MODEL BENTLEY MARK VI

COLUMN GEAR CHANGE(LEFT-HAND DRIVE CARS)FOR INFORMATION:

FOR INFORMATION:THE AUTOMATIC GEARBOXAddendum to BB.151.

MODIFICATIONGearbox Tie-Rod Bracket.1. GENERAL

FIG. 1. DESIGN DIFFERENCES - REAR END.

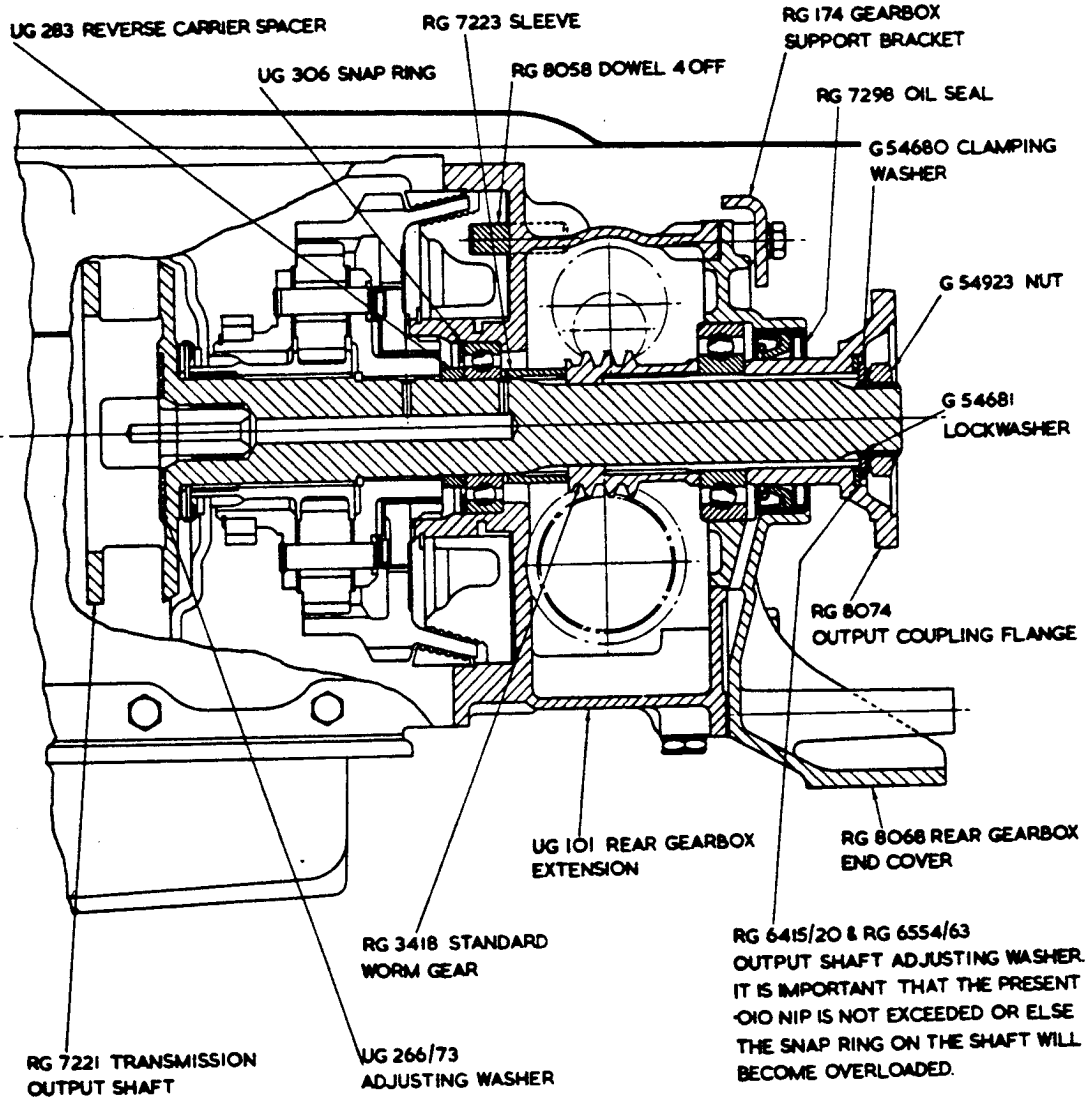
These modifications do not affect the principles of the Hydra-Matic design which remain unaltered, but allow for the incorporation of additional Bentley design features.

The main differences are embodied in the rear extension of the gearbox (see drawing attached) where the parts of Bentley design are shown in section. Original Hydra-Matic parts are shown in outline only.

The rear extension casting has been re-designed to incorporate the Bentley wheel-brake servo motor, ride control pump, speedometer drive gear, and gearbox output shaft, on which the reverse epicyclic unit from the original Pontiac rear extension is mounted. The ride control pump, which provides variable damping to the rear shock absorbers, employs Automatic Transmission fluid taken from the gearbox sump by means of a pipe through the orifice normally used in 1952 G.M. cars for "under-hood" gearbox filling. The filling of the Bentley Automatic Gearbox is, therefore, carried out through the dipstick orifice.

The throttle-valve linkage has been re-designed to give slightly altered upshift characteristics. The manual control lever on the steering column, and the operating linkage, the starter ring, flywheel and divided bell housing are also of Bentley manufacture.

FIG.1 THE FLEXIBLE PIPE RE-POSITIONED.

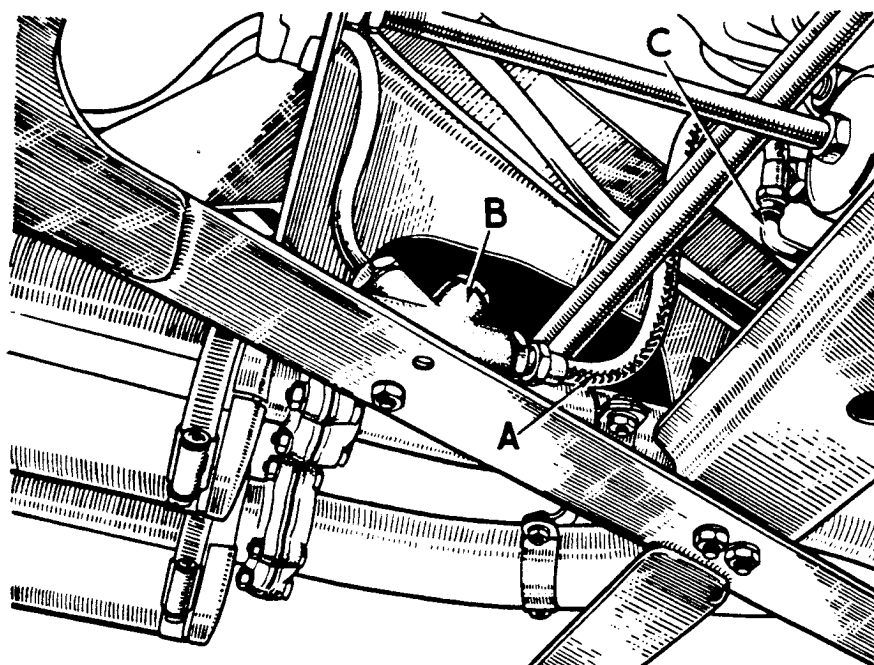
Experience has shown that, on the left hand drive Bentley 'R' Type fitted with an Automatic Gearbox, the flexible pipe from the ride control pump to the four-way union mounted on the frame cruciform member just behind the gearbox, can be burnt by fouling the exhaust pipe. In exceptional cases this may lead to considerable loss of oil from the gearbox, which, although causing no permanent damage, will give rise to immediate erratic and noisy operation. A shorter pipe, Part No. RF.9971, has been fitted on production on chassis No. B-20-UN and from B-26-UN onwards.

Retailers should check all left-hand drive 'R' Type Bentleys, fitted with an Automatic Gearbox, in their area at the earliest opportunity on service and if necessary, reposition the flexible pipe as described below.

- A. Repositioned Flexible Pipe. C. L-Shaped Outlet Pipe.
 B. Four-Way Union.

FIG. 1 EXPLODED VIEW OF
RIDE CONTROL
PUMP.

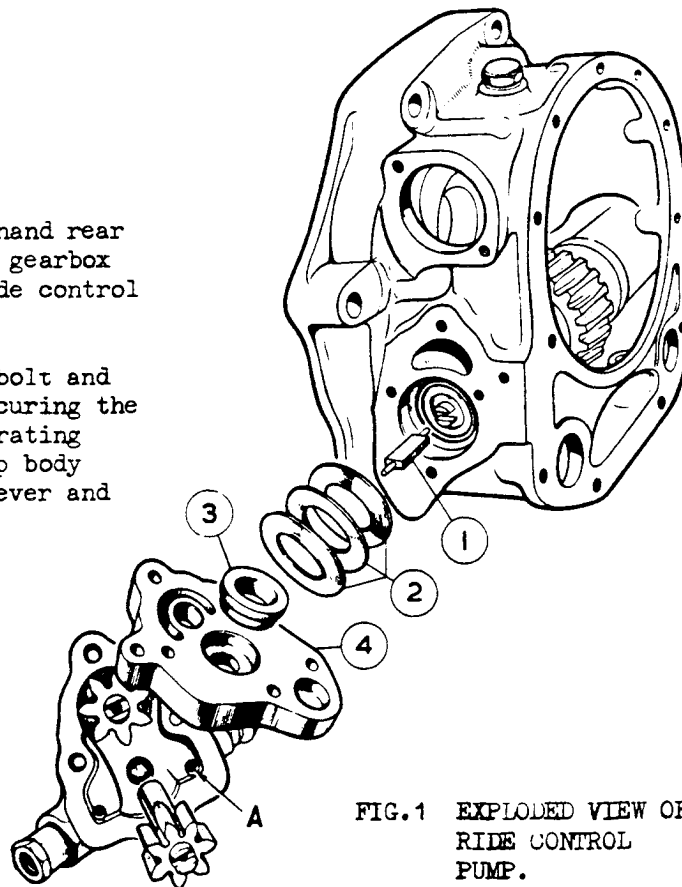
This Bulletin details the method of correction and incorporates a modification for increasing the diameter of the pump intake passage, which further improves its operation.

(iv) Remove the four screws retaining the pump to the gearbox rear extension and remove the pump. Collect the driving key (1 Fig.1).

(v) Remove the two screws securing the intermediate plate (4). The plate will spring outwards as the screws are loosened under the influence of the three Belleville washer (2) which apply the pre-load to the taper bearing. Remove the plate and collect the Belleville washers and distance piece (3).

VIEW LOOKING ON TOP OF FRAME SHOWING NEW RUBBER SEATING & BRACKET STIFFENERS FITTED

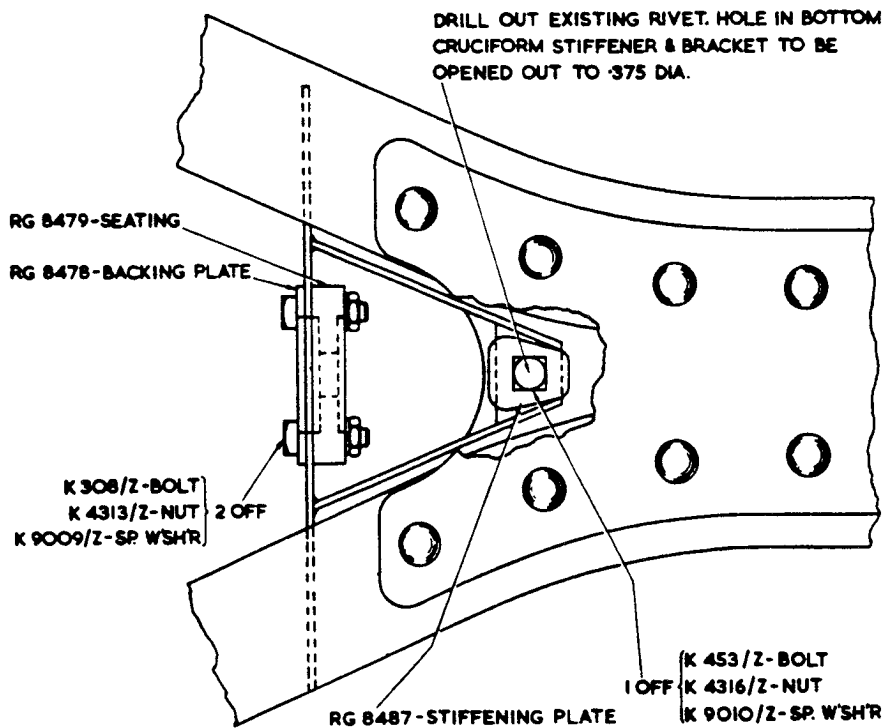
Details of both modifications are set out in this Bulletin and Retailers are asked to incorporate them on a Category 2 basis, dealing with cars as they come in for service.

The original Mark VI type bracket is now being fitted on production. Both modifications apply equally to cars fitted with either automatic or synchromesh gearbox.

- (i) Place the car on a ramp or over a pit.
- (ii) Remove the gearbox tie-rod by removing the two nuts and spring washers retaining the rubber seating to the gearbox at the front end and to the mounting bracket at the rear end.

- (iii) Drill out the existing rivet securing the bracket to the lower cruciform stiffening plate (Fig.1). Enlarge the hole to .375" (9.52 mm) dia. Fit the bolt and stiffening plate. The stiffening plate fits between the bolt head and upper face of the bracket.
- (iv) Fit the new rubber seating and backing plate (Fig.1).
- (v) Discard the old rubber seating and refit the tie-rod.

VIEW LOOKING FROM FRONT OF CAR SHOWING
MODIFICATION TO EXISTING TIE ROD BRACKET

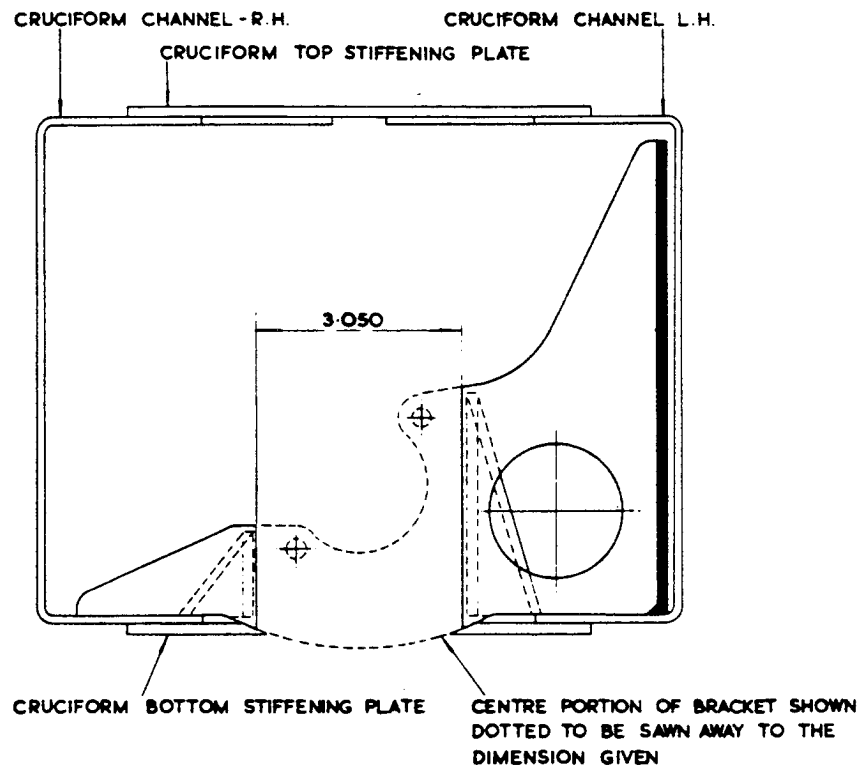
3. WELDED FRAMES MODIFICATION(a) Chassis Nos. AffectedBentley 'R' Type

- (i) Place the car on a ramp or over a pit.
- (ii) Remove the gearbox tie-rod by removing the two nuts and spring washers retaining the rubber seatings to the gearbox at the front end and to the mounting bracket at the rear end.
- (iii) Cut out the centre portion of the transverse mounting bracket with a hacksaw as shown in Fig.3. Clean up and paint the cut edges.

FIG.3 TO MODIFY THE THIRD MOTION SHAFT
RG.5469 to RG.8530.

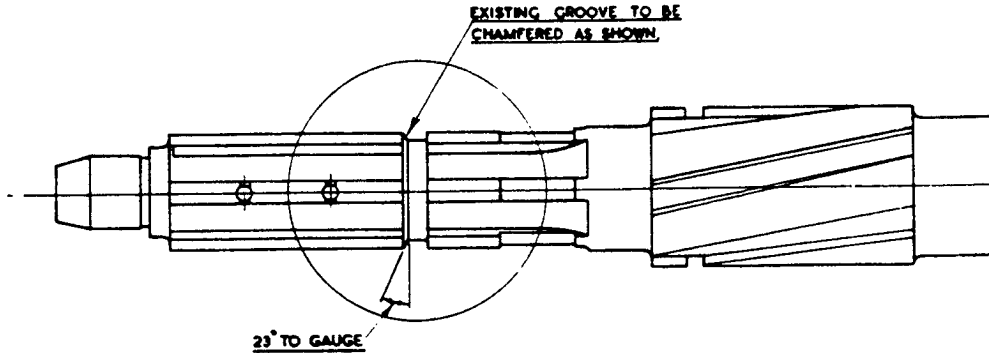
On current production a washer of .275" (6.98 m/m) thickness is now being fitted. Its fitting requires machining operations to existing parts which it is not intended should be undertaken on a service basis. However, full details are included in the second part of this Bulletin for information and for guidance where sufficient new parts are being fitted to warrant fitting the production type washer.

The chamfer on the front face of the groove in the third motion shaft should be ground off if necessary using the thrust washer itself as a gauge. The washer should rotate freely in the groove but endfloat must not exceed .004" (.10 m/m).

FIG.4 TO MODIFY 3RD MOTION SHAFT
RG.5469 to RG.8472

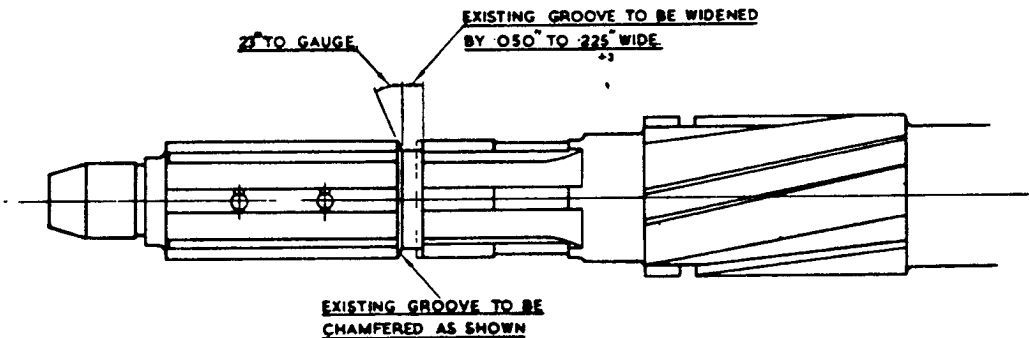
| (or RG.5469 modified to RG.8472 - Fig.4) | | |

The machining operations are detailed in Figs.4,5,6 and 7. The sleeve RG.8461 may be turned in a lathe using a carbide tipped cutting tool but other parts should be ground. The machining of the 3rd speed gear requires an internal grinding machine.

FIG. 5 TO MODIFY 3RD SPEED GEAR RG.100 TO RG.8459.

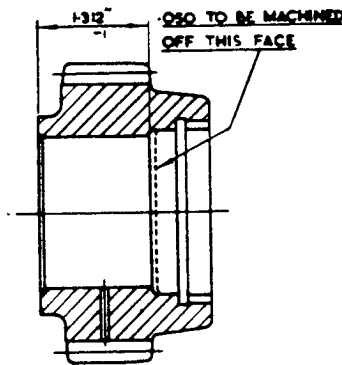
| (or RG.100 modified to RG.8459 - Fig.5) | | |

FIG. 6 TO MODIFY SLEEVE GB.5374 TO RG.8461.

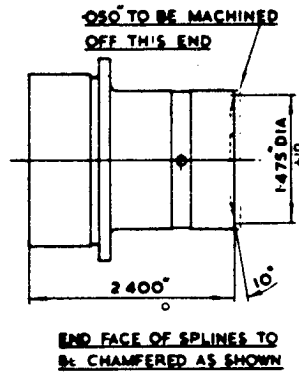
| (or GB.5374 modified to RG.8461 - Fig.6) | | |

FIG. 7 TO MODIFY SLIDING PIECE RG.5470 TO RG.8467.

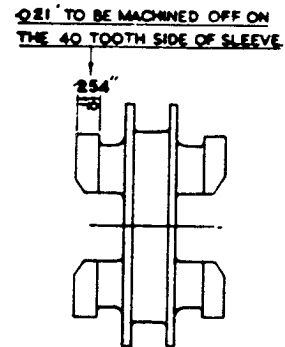
| (or RG.5470 modified to RG.8467 - Fig.7) | | |
